ADDENDUM NO. 3

Project Name: Building Renovation for Haverford Township Free Library
Project No.: 7010.03-22
Date of Issue: October 10, 2023
Notice 1: Attach this addendum to the Project Manual for this project. It modifies and becomes part of the Bidding Documents. Work or material not specifically mentioned herein is to be as described in the main body of the Project Manual, and as shown on the drawings.

Sheet Title:
FOUNDATION PLAN

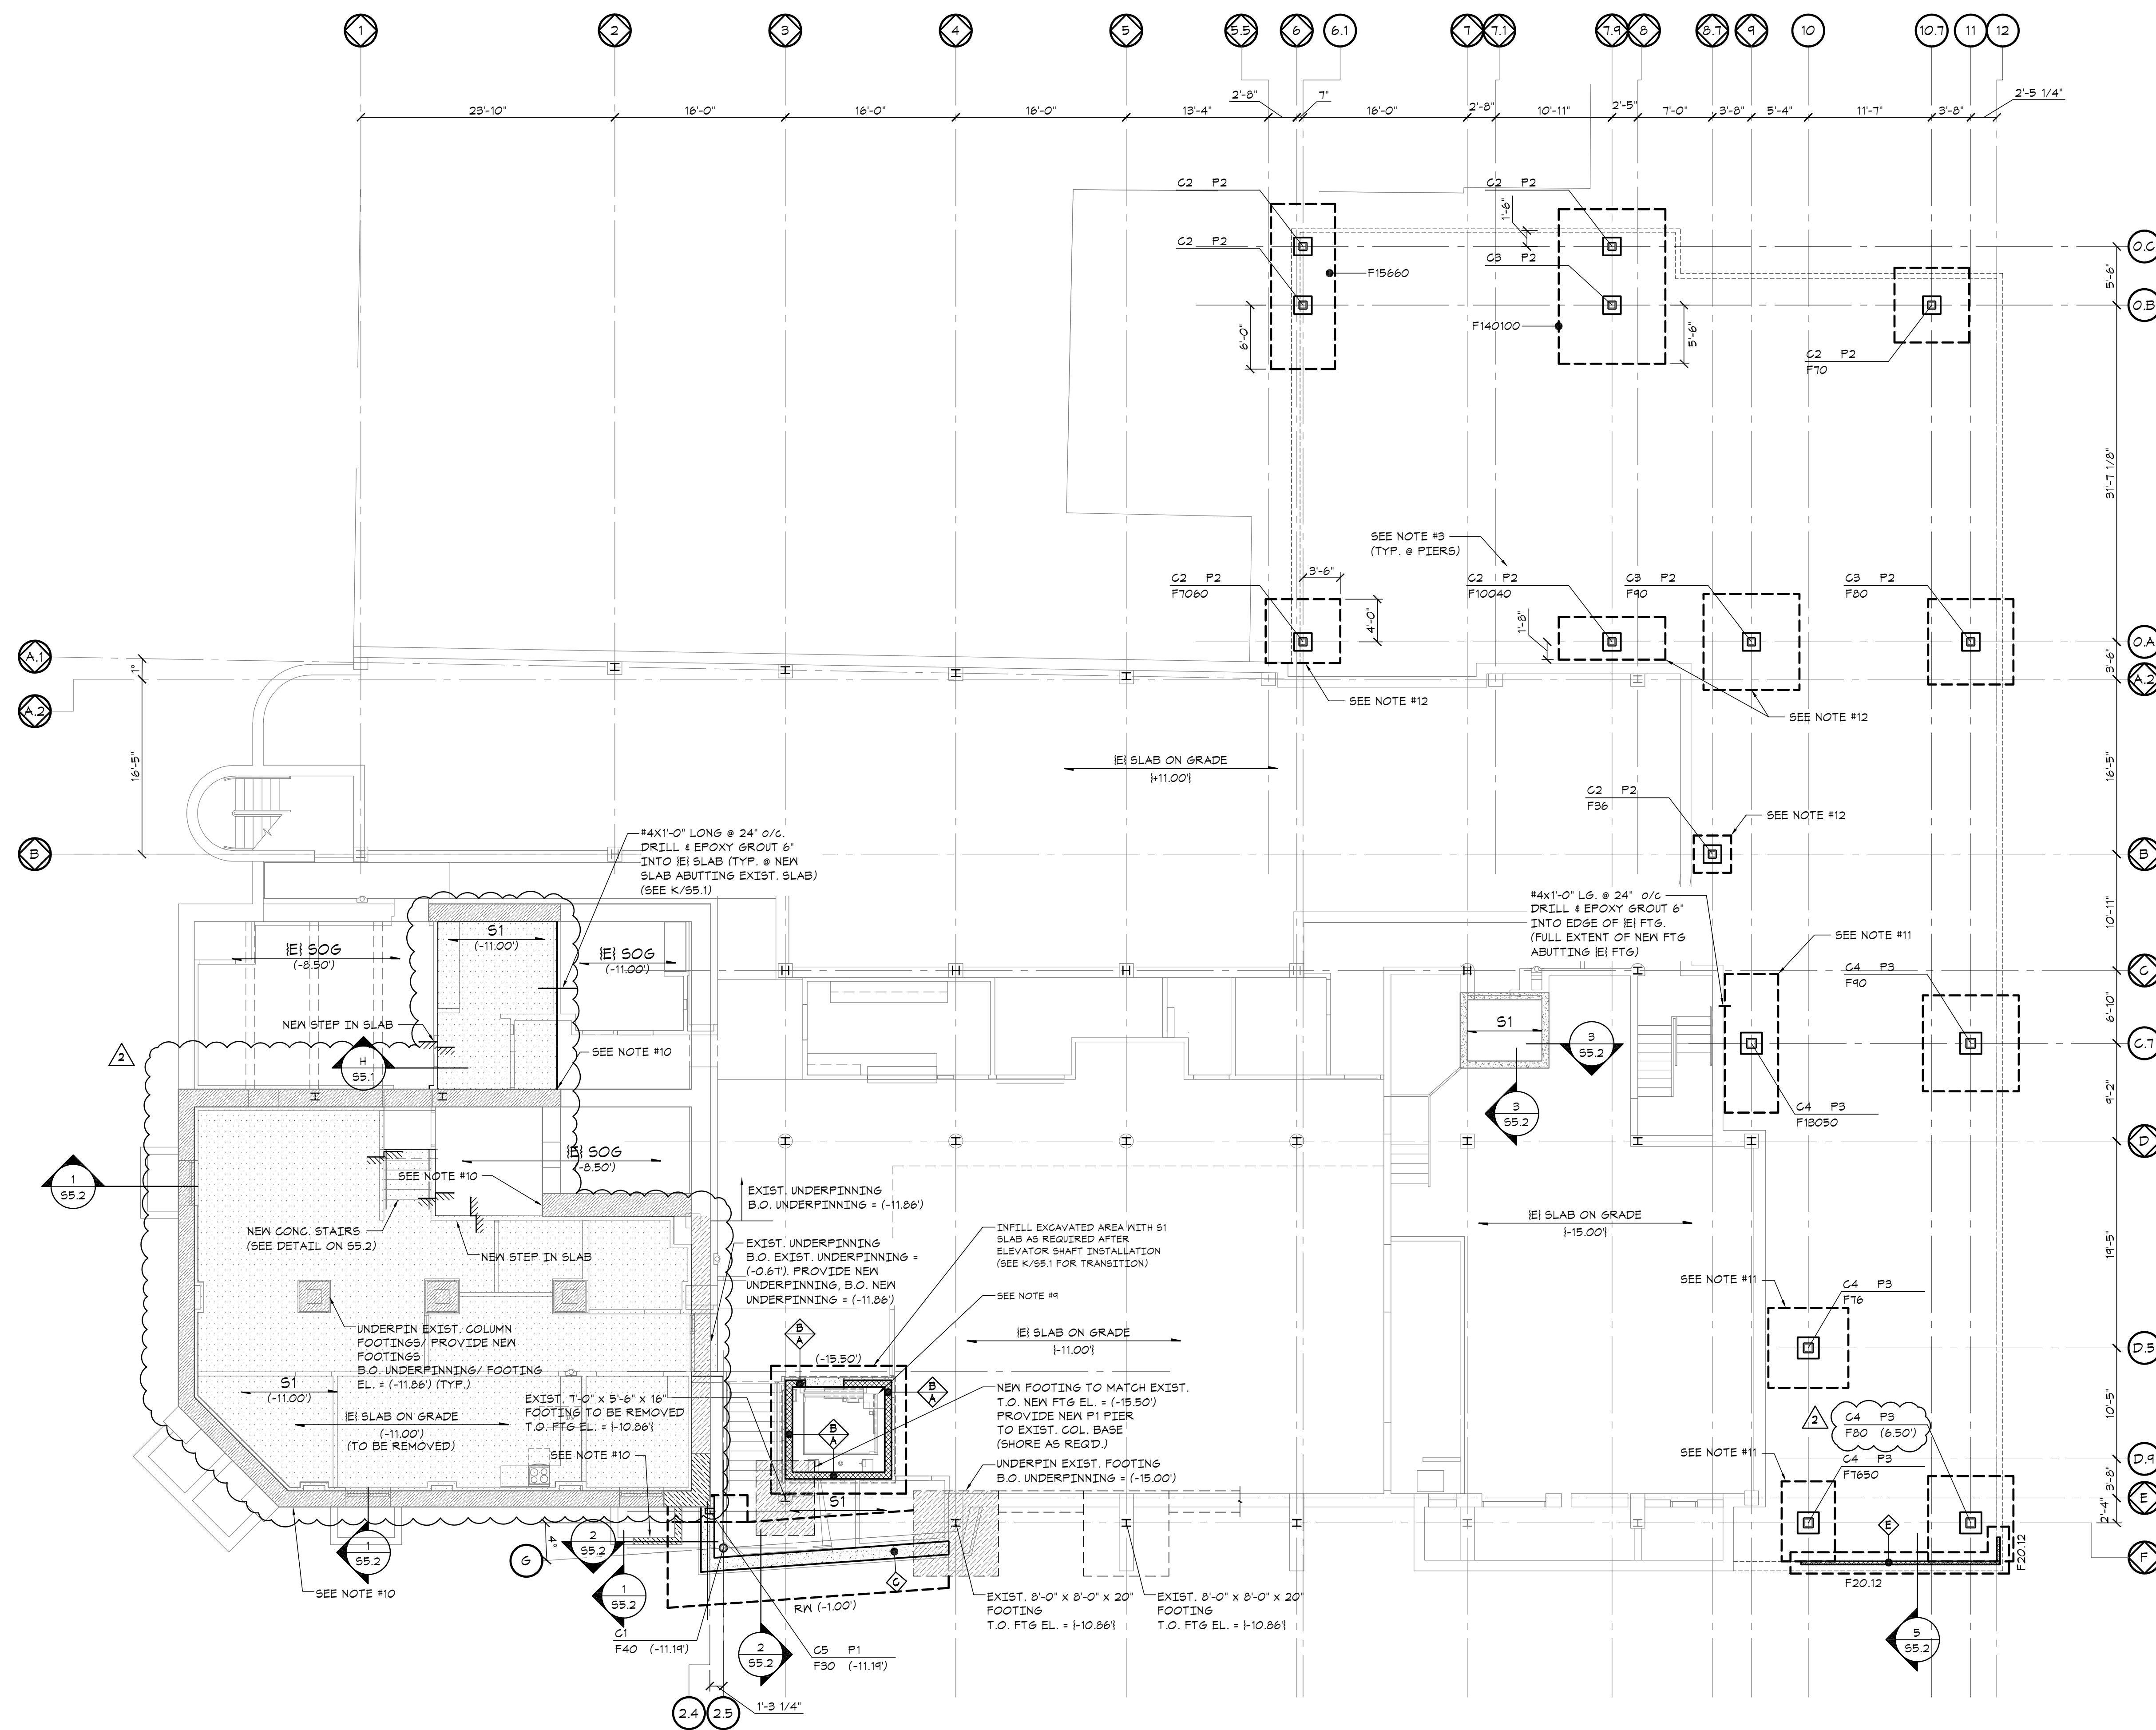
3. On Sheet **S1.0**, add extent of existing floor slab in basement to be removed as part of the lowering of the basement floor, add Note 13, and add elevation of footing at column F/11. The revised sheet is attached as part of this addendum.

S1.1

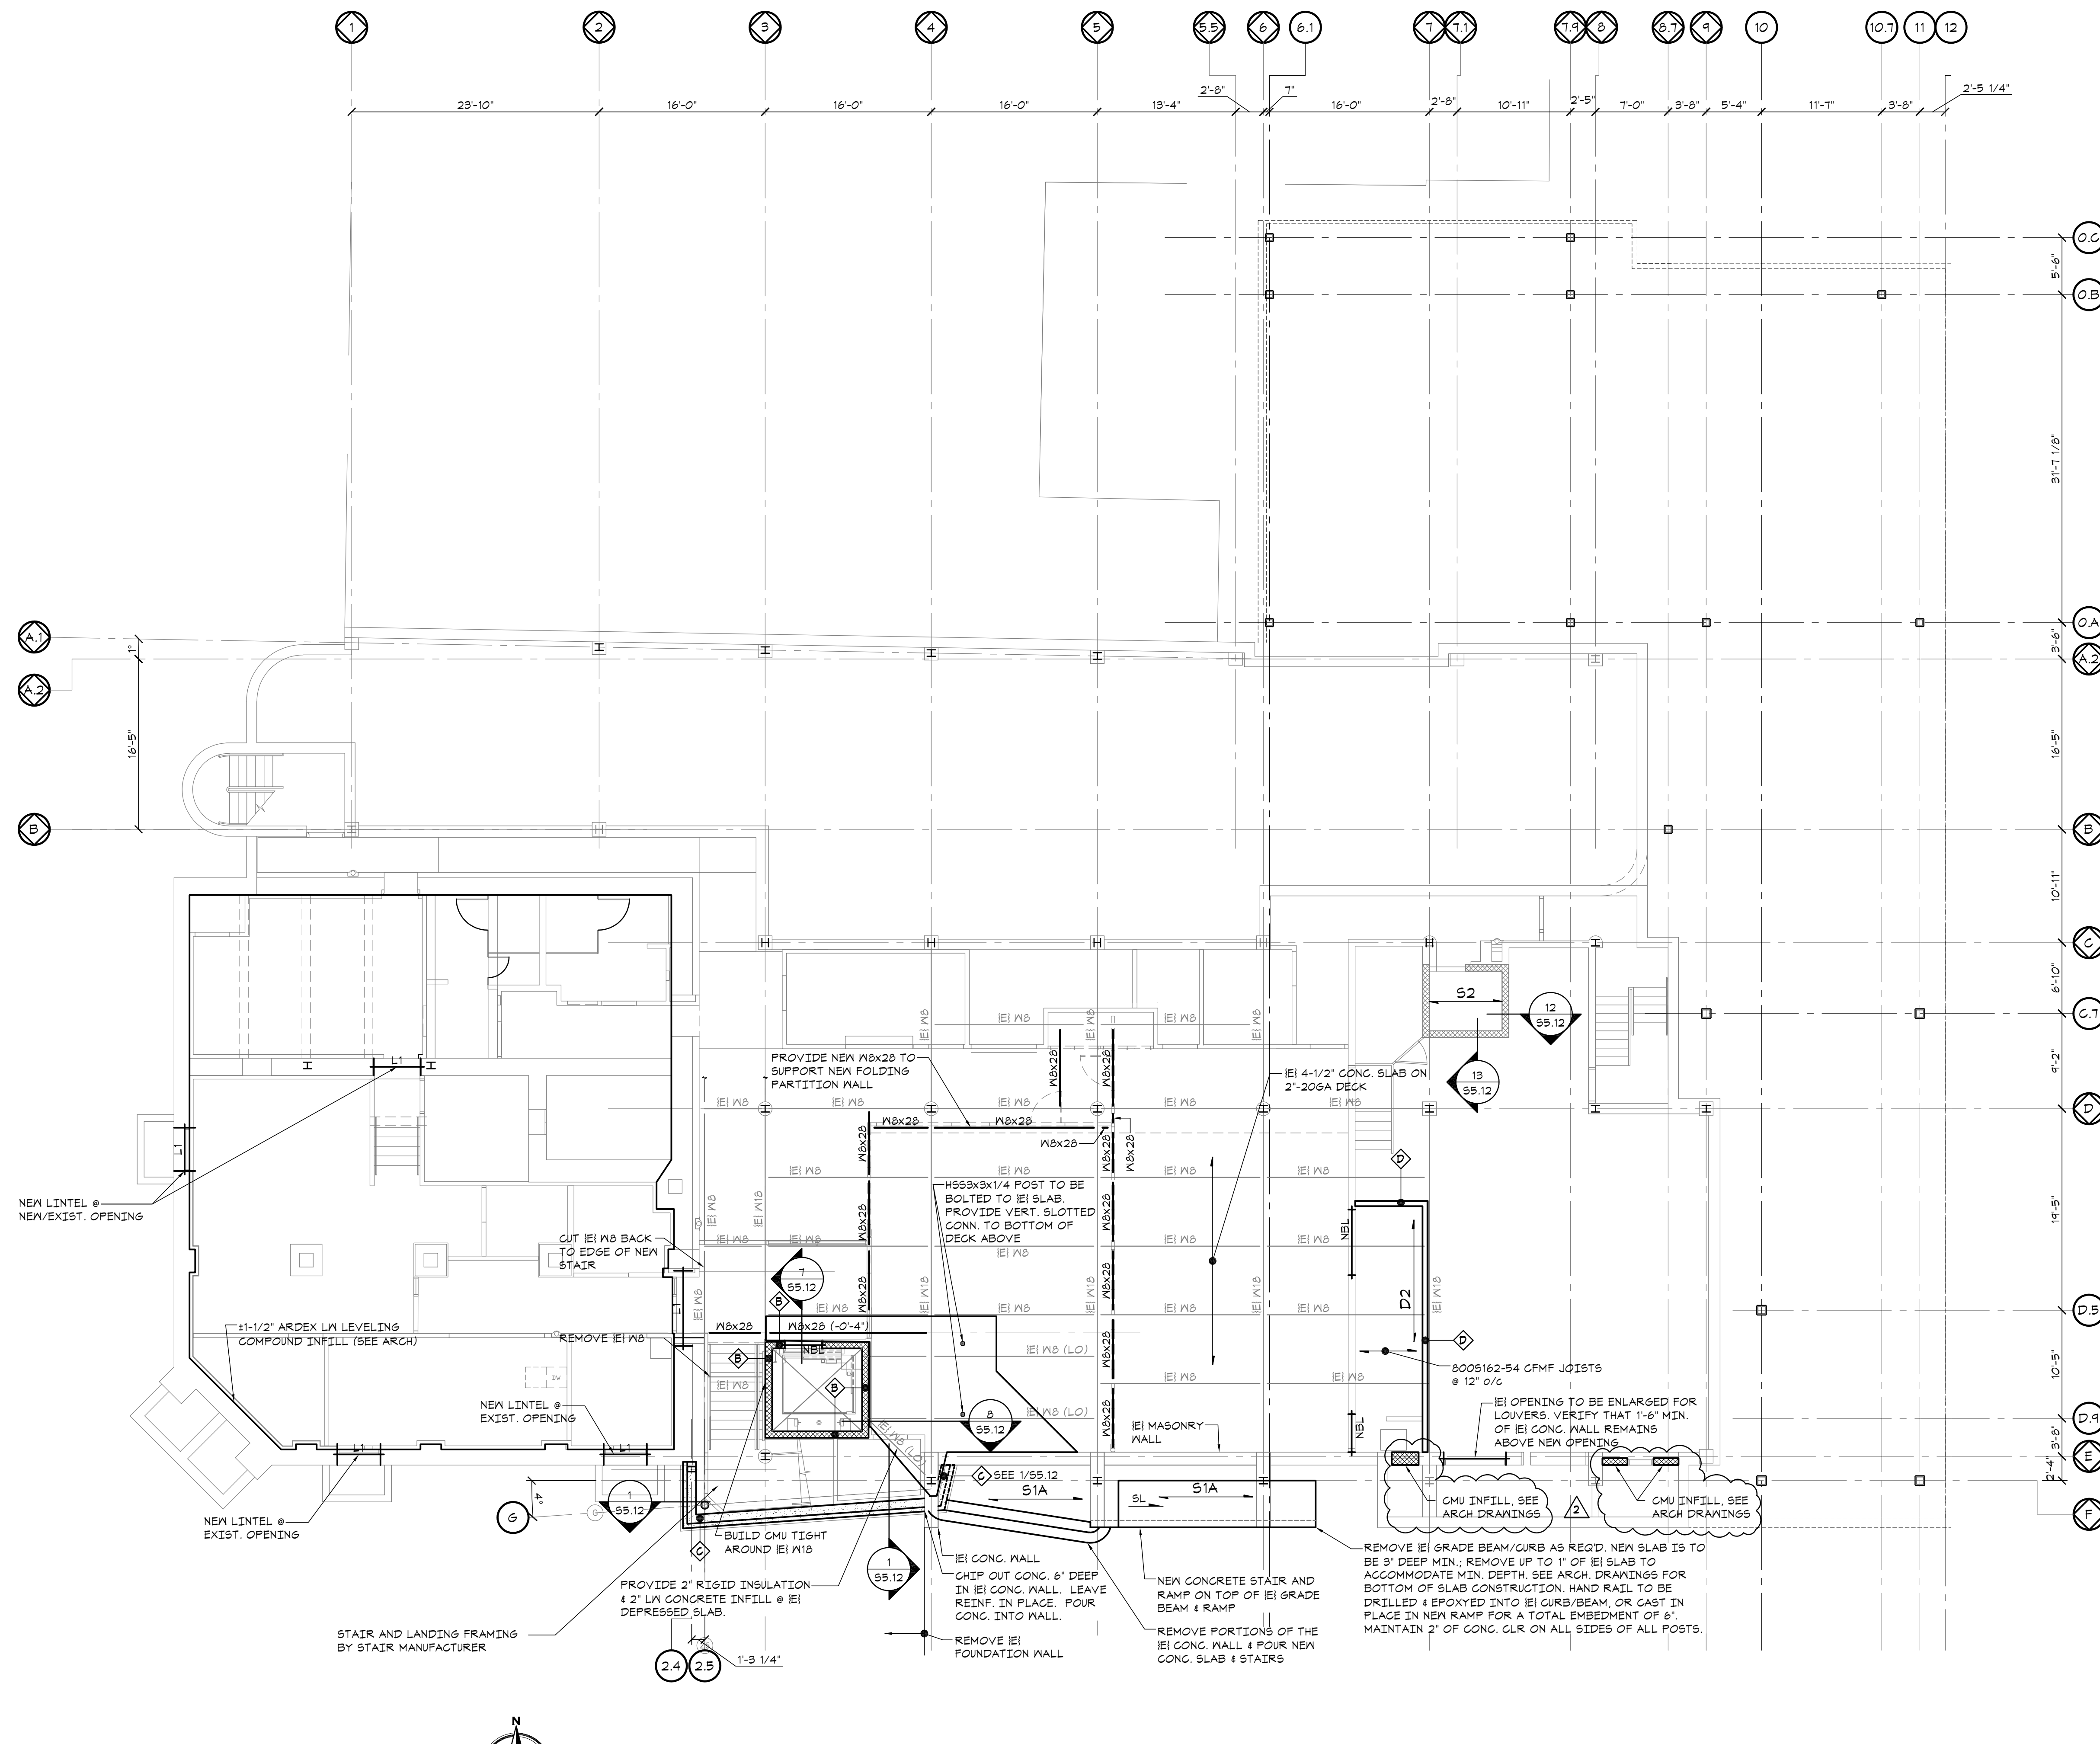
4. On Sheet **S1.1**, add CMU infill in openings at Mechanical Room areaway and add Note 8. The revised sheet is attached as part of this addendum.
5. On Sheet **S1.2**, add Note 10. The revised sheet is attached as part of this addendum.

Sheet Number:
S1.3

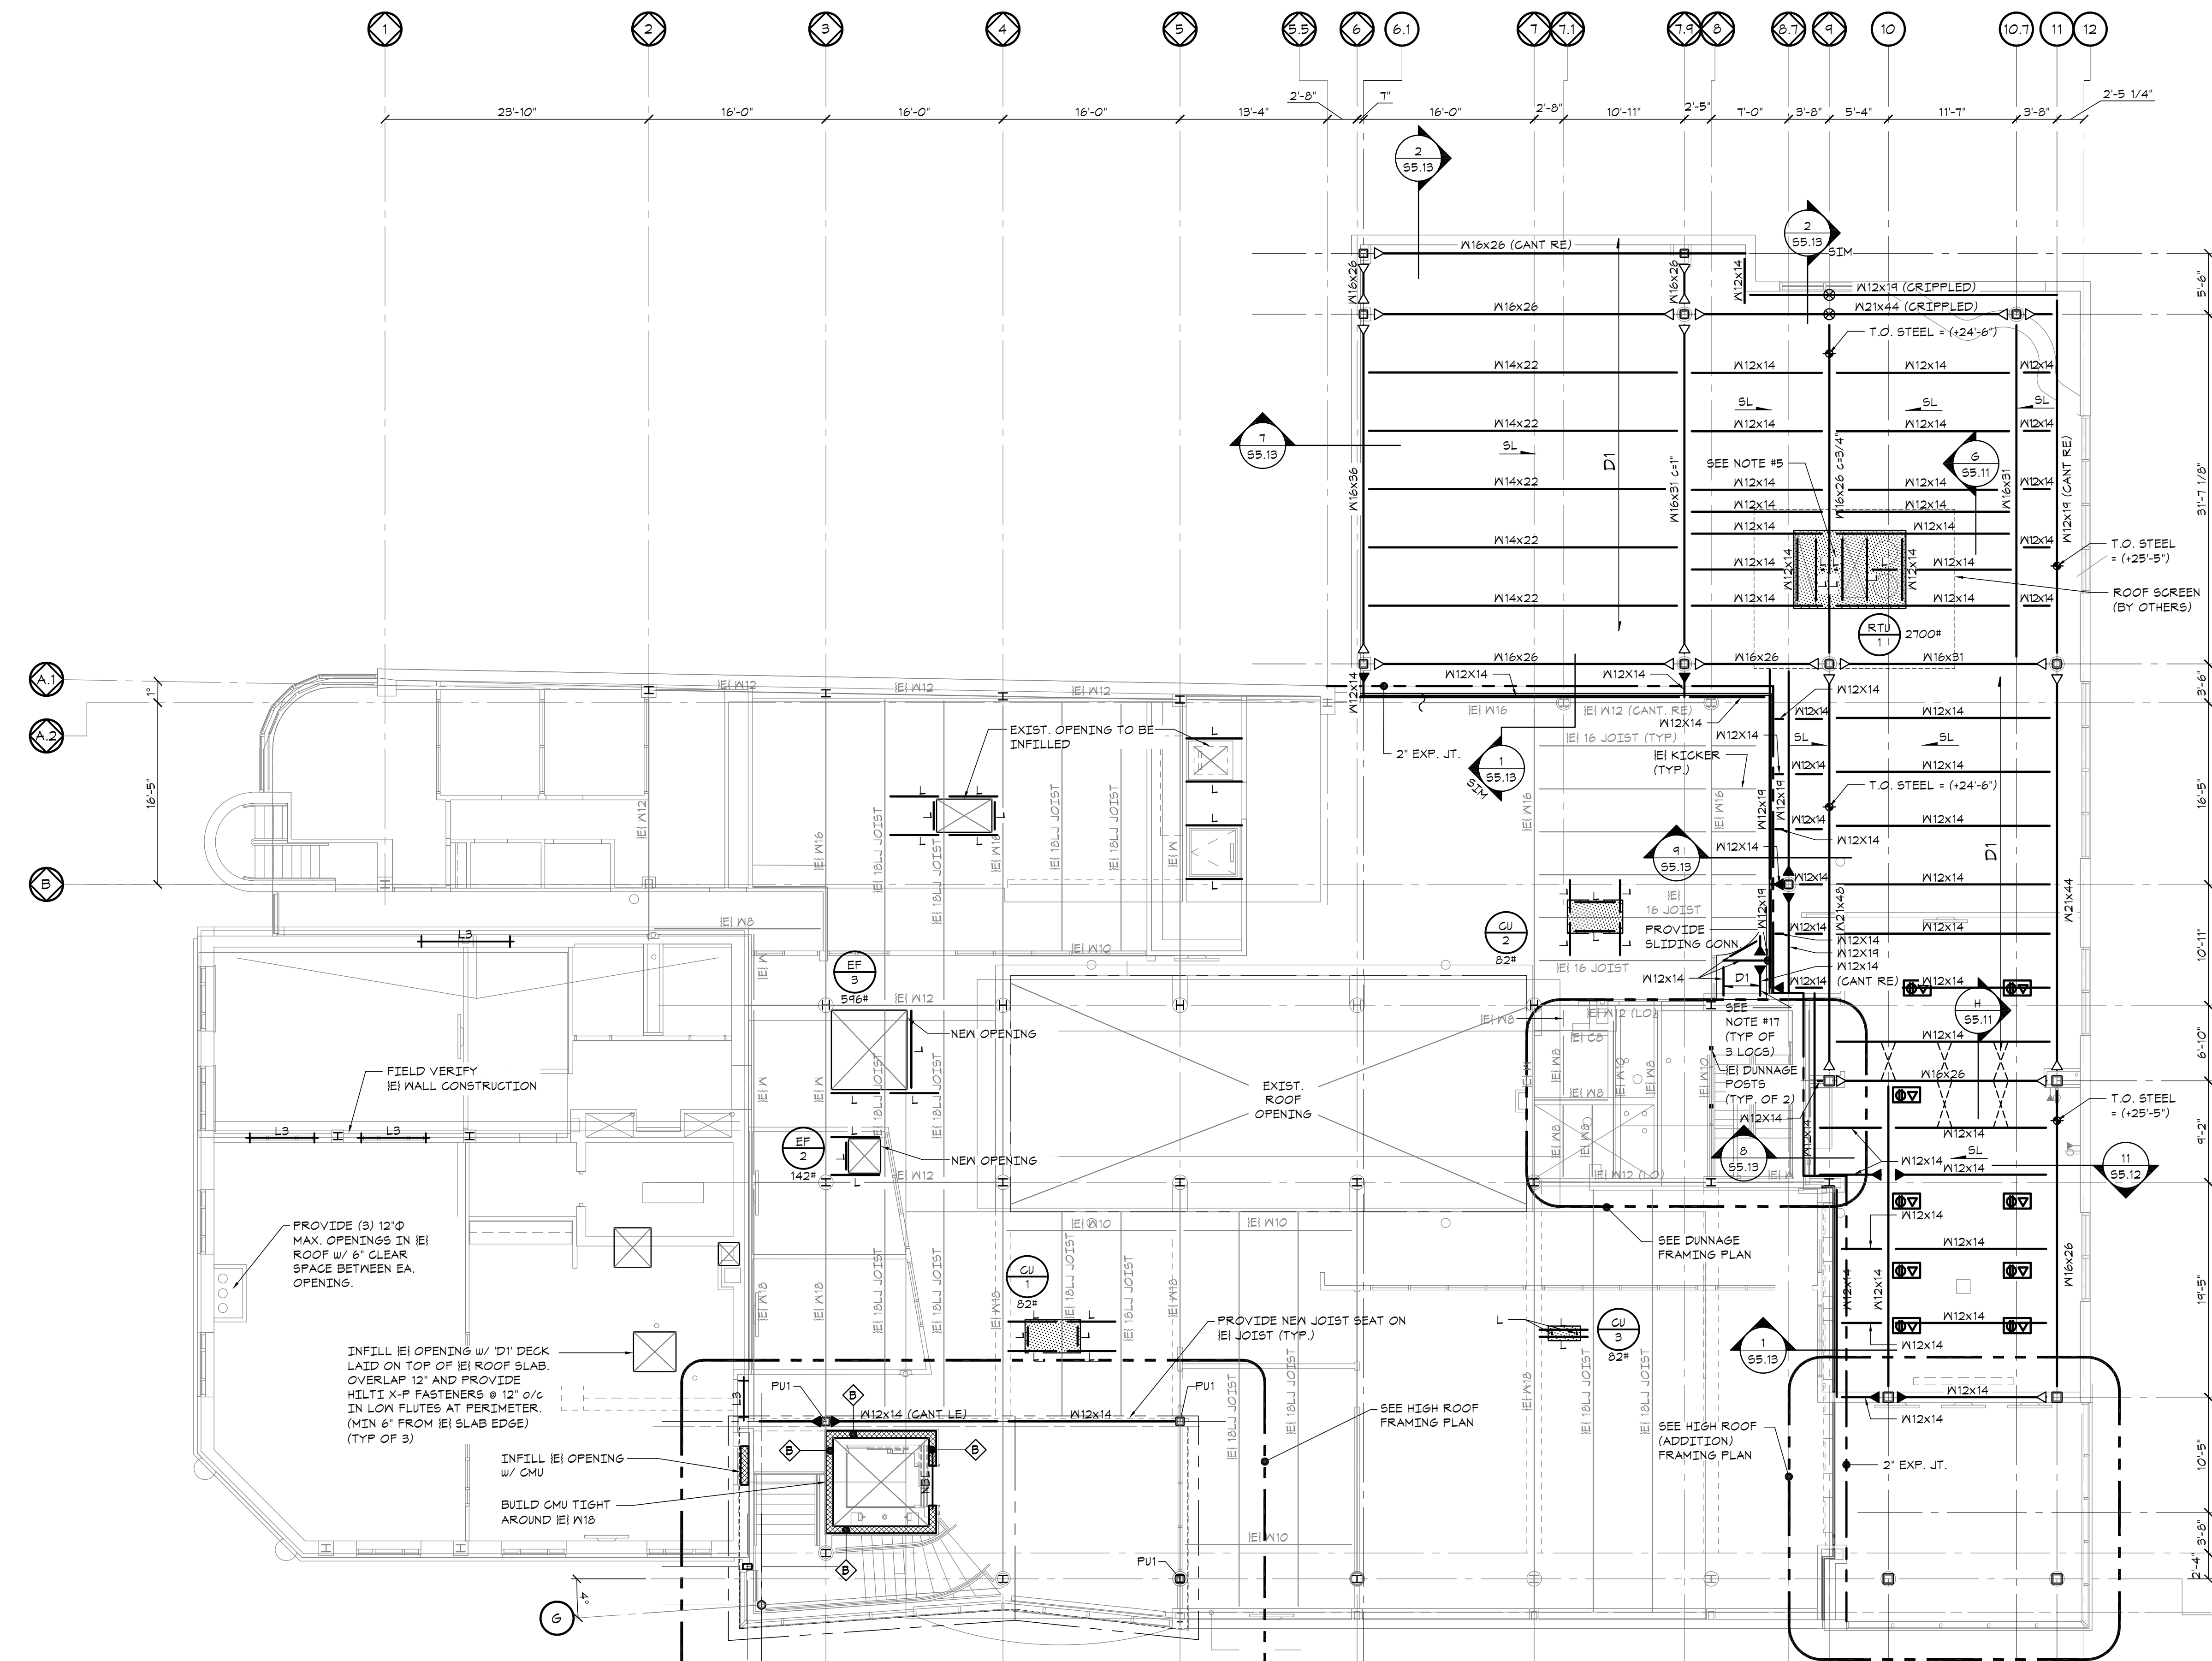
6. On Sheet **S1.3**, add Note 21. The revised sheet is attached as part of this addendum.
7. On Sheet **DMPE1.0**, revise Mechanical Demolition Notes, Plumbing Demolition Keynotes, Electrical Demolition Keynotes, and Electrical Demolition Notes as indicated. The revised sheet is attached as part of this addendum.
